Topic: Manistee North Pierhead Light—Safety Railing
To: State Historic Preservation Office & National Park Service
From: Sable Points Lighthouse Keepers Association (SPLKA)
Date: April 17, 2025

UPDATED ON: April 30, 2025

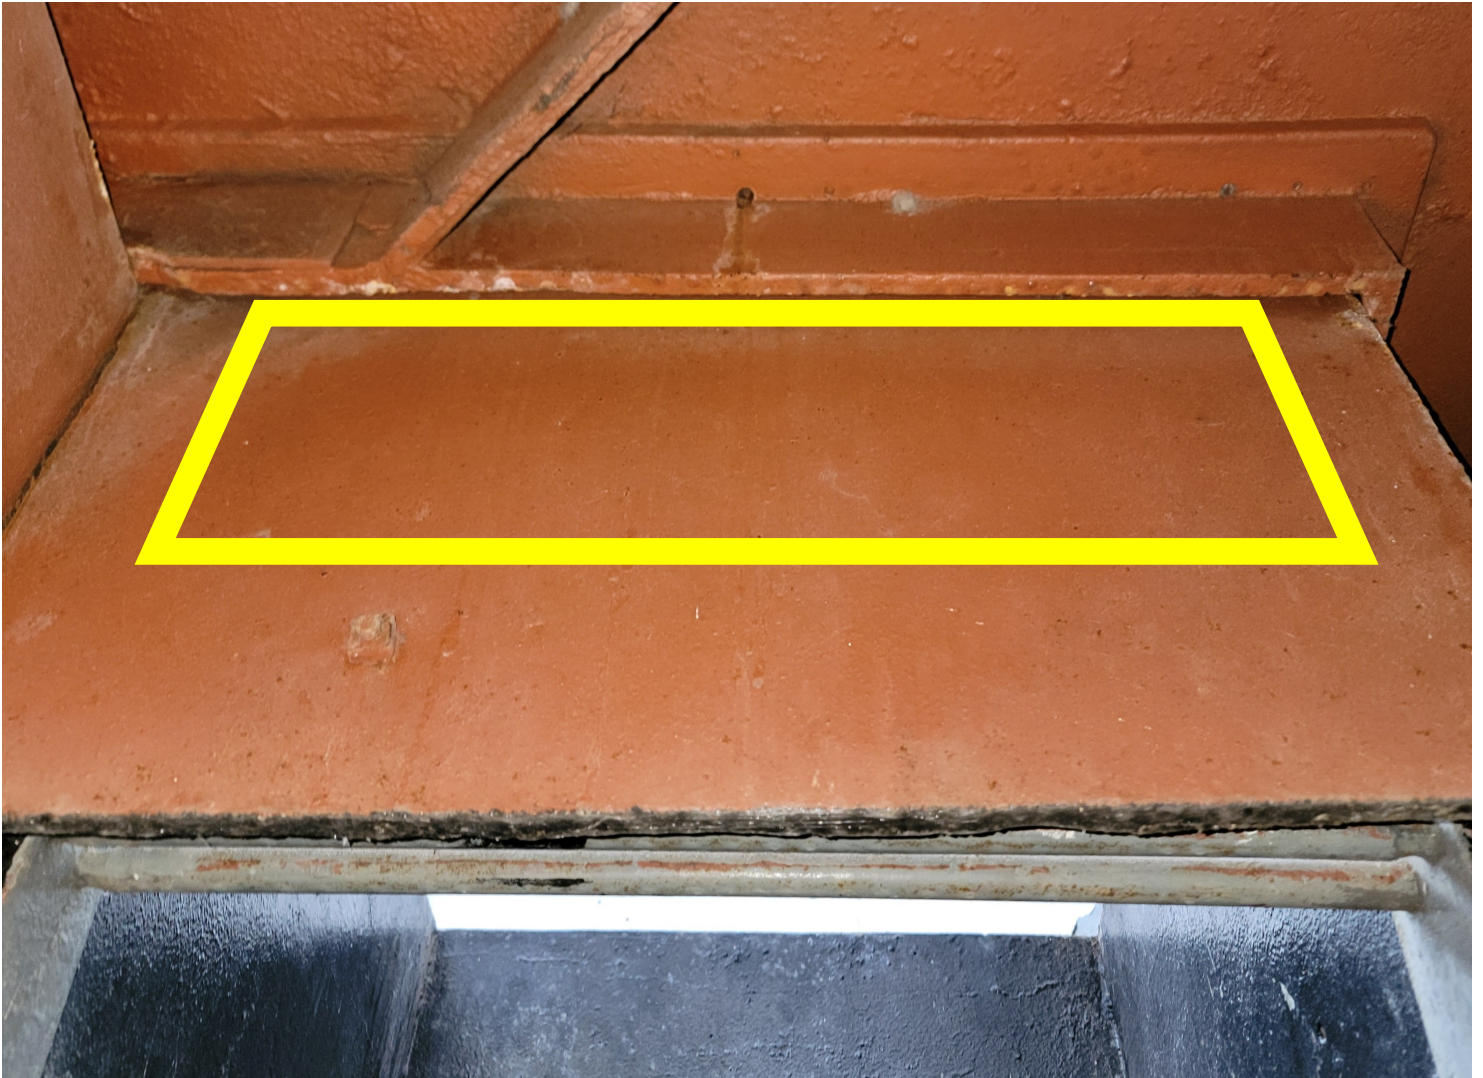
Ladder to Level 4: Using existing holes, a handhold will be added to the vertical structural beam. This is indicated in Red in the diagram below.

A middle railing will be added in the existing guard railing seen in Yellow using slide-on fittings.

The equipment bracket that is located on the floor of the fourth level will be removed as outlined in the HSR.
